Construction Division
Additions & Alteration Charges Approval Form

Quality Control Check Report Stage After Finishing Stage III (Apartments)

MAYFLOWER PLATINUM

Details of Additions & Alterations

ELECTRICAL PLAN OF FLAT-A8

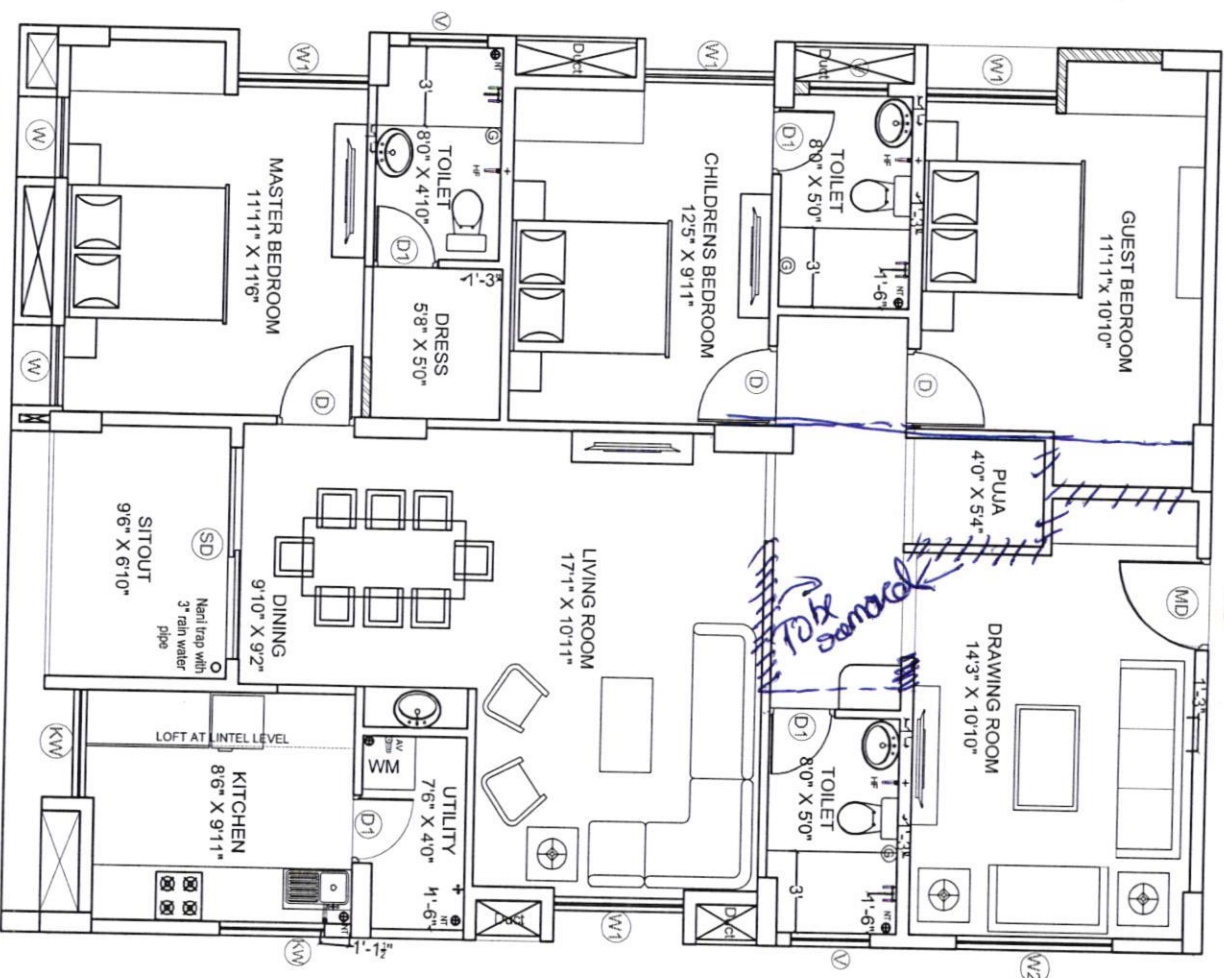
Changes in electrical points: (mark on plan)

Kitchen Entrance wall 1 extra plug point.
